**LEVY NUCLEAR PLANT, UNITS 1 AND 2  
DOCKET NOS. 52-029 AND 52-030**

**RESPONSE TO REQUEST FOR ADDITIONAL INFORMATION LETTER NO.104 RELATED TO  
PROBABLE MAXIMUM SURGE AND SEICH FLOODING**

**Levy Nuclear Plant Units 1 and 2  
Response to NRC Request for Additional Information Letter No. 104 Related to  
SRP Section 2.4.5 for the Combined License Application, dated May 19, 2011**

**NRC RAI NUMBER:** 02.04.05-11

SLOSH Display Map at LNP Site for  
Scenario 1 With Higher Initial Water Level  
of 3.87 ft. NAVD88  
FIGURE RAI 2.4.5-11-1

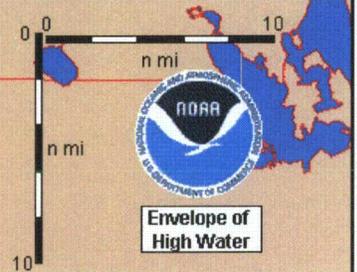
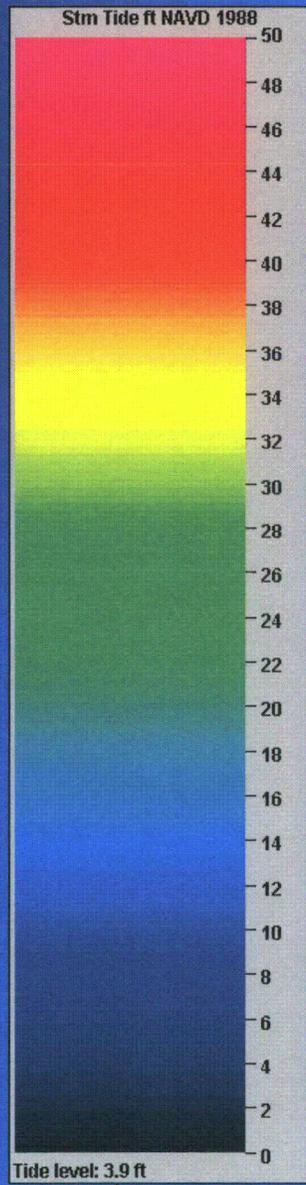
Using the higher initial water level of 3.87 ft. (NAVD88), and all other input data used for Scenario 1 discussed in FSAR Subsection 2.4.5.4, an additional SLOSH model run was performed. Figure RAI 2.4.5-11-1 provides the SLOSH display screenshot at the time of the peak PMH surge level.

As shown in Figure RAI 2.4.5-11-1, the PMH maximum surge elevation from the SLOSH model run is 47.7 ft. NAVD88 which is the same as the maximum surge elevation computed for Scenario 1.

In Subsection 2.4.5.4.7 Scenario 1, which resulted in maximum PMH surge, an initial water level of 1.16 m (3.82 ft.) NAVD88 was used based on observed tide data. An additional SLOSH run was performed with a higher initial water level of 3.87 ft. NAVD88 along with other input data used for Scenario 1. The PMH surge level obtained for this run was 14.54 m (47.7 ft.) NAVD88, which is the same as obtained for Scenario 1. Figure 2.4.5-247 shows the maximum surge at the LNP site for this additional SLOSH run.

**New Figure 2.4.5-247**
